# **PUBLIC INVOLVEMENT SUMMARY**

**SH-74 Bridge over I-35  
Replacement/Interchange  
McClain County, Oklahoma  
JP 29571(04)**

**March 2023**

**FIGURE ES.1: SH-74 BRIDGE SKEW OVER I-35**

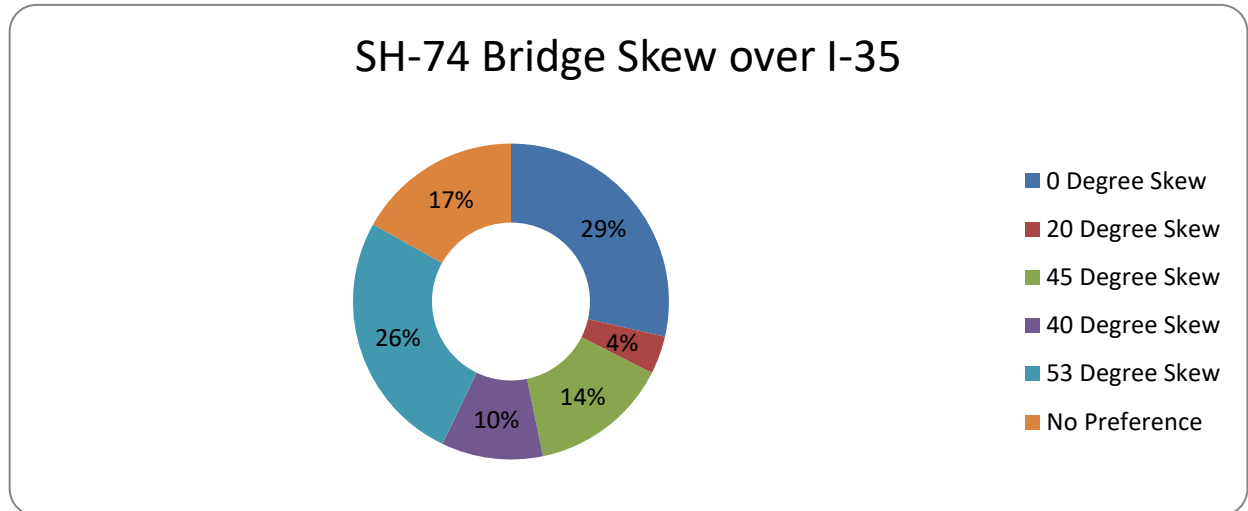
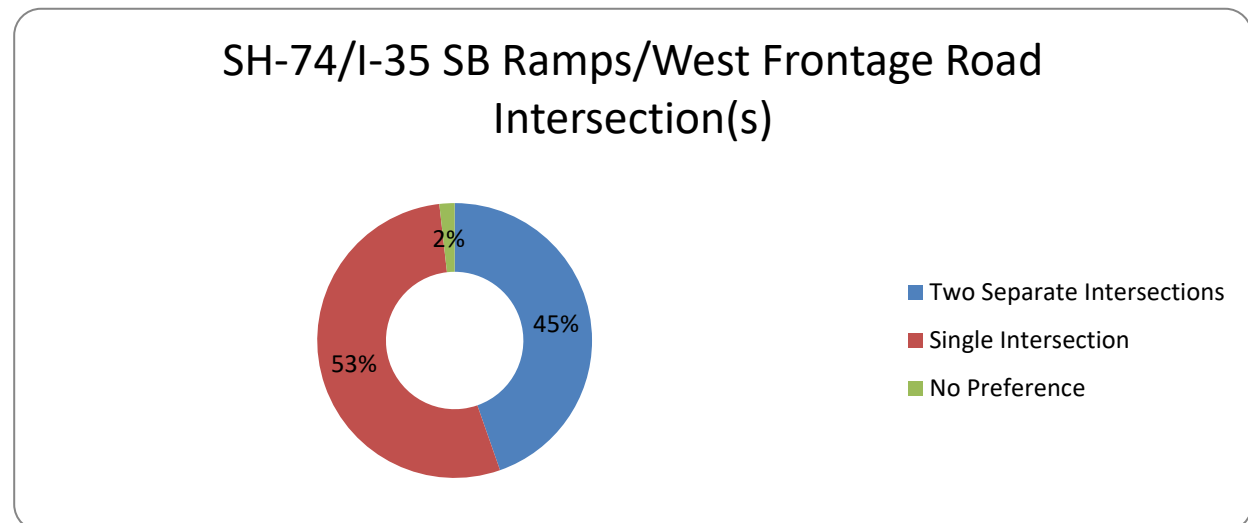
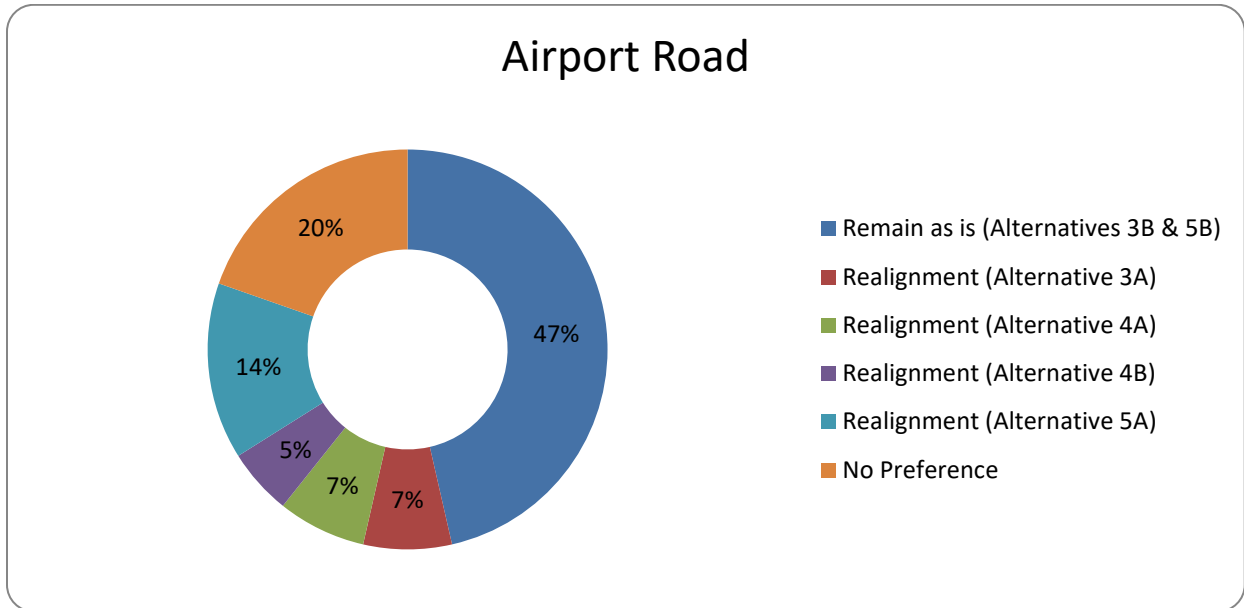
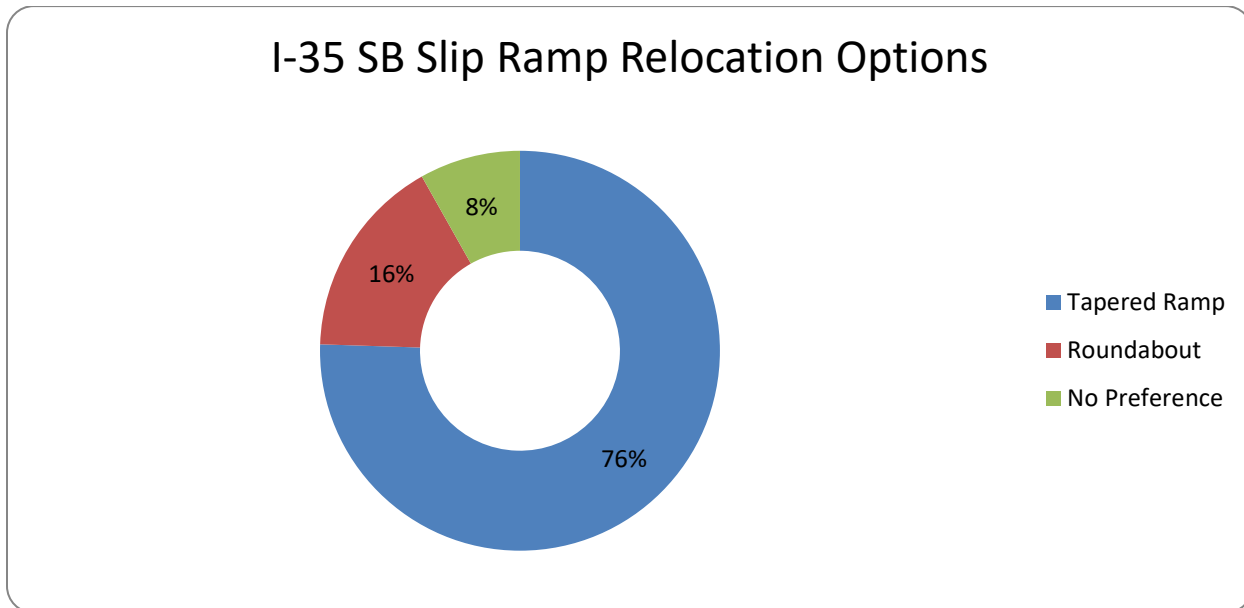
*Support for/opposition to specific options.*

**ODOT Response:** Thank you for your comment. ODOT values your participation in this process and your comment has been included in the project record. Please refer to **Figures ES.1, ES.2, ES.5,** and **ES.6** above to see the results of the public participation survey.

**FIGURE ES.3: DESIGN OF SINGLE INTERSECTION OF SH-74/I-35 SOUTHBOUND RAMPS/WEST FRONTAGE ROAD**

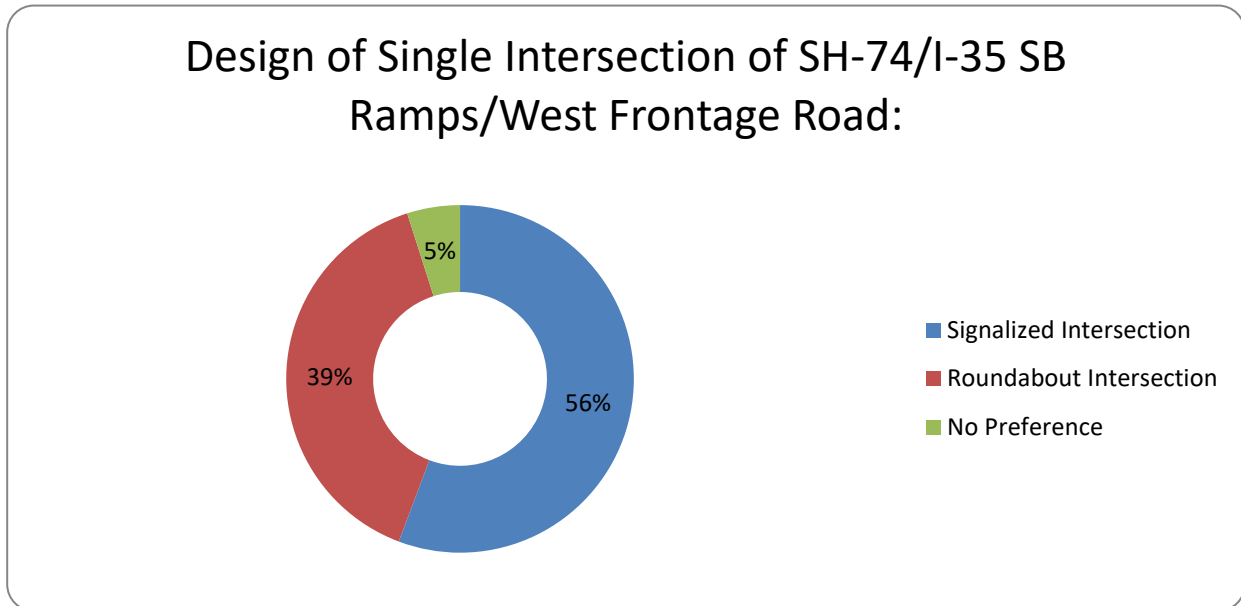
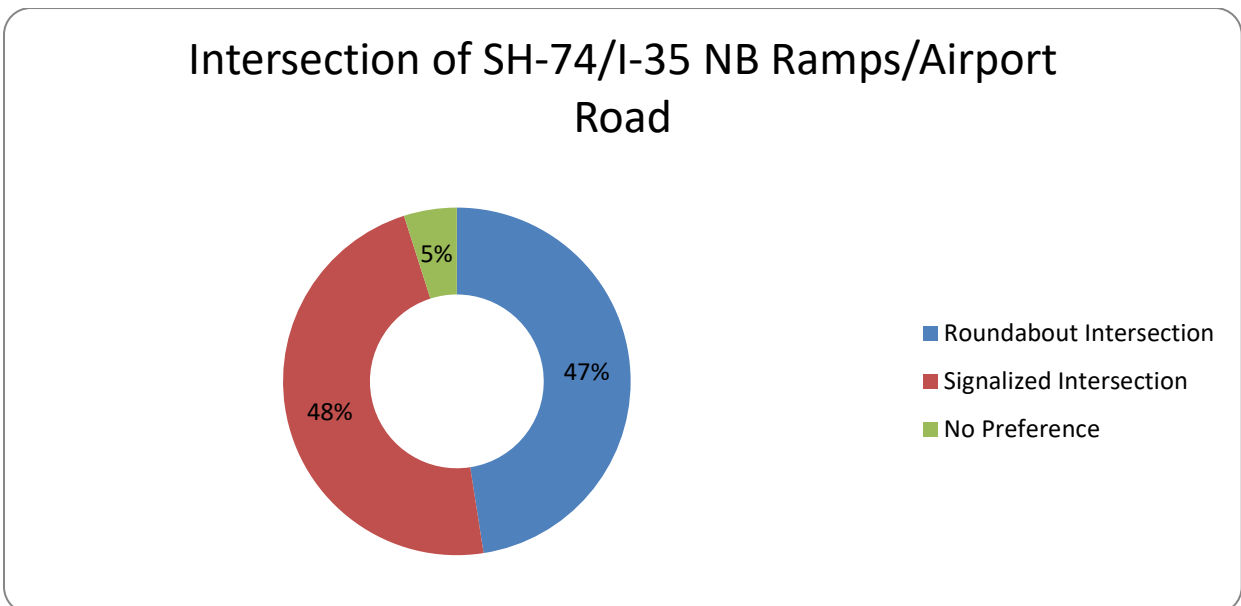
*Comments regarding roundabouts.*

**ODOT Response:** Thank you for your comment. ODOT values your participation in this process and your comment has been included in the project record. Please refer to **Figures ES.3** and **ES.4** above to see the results of the public participation survey.
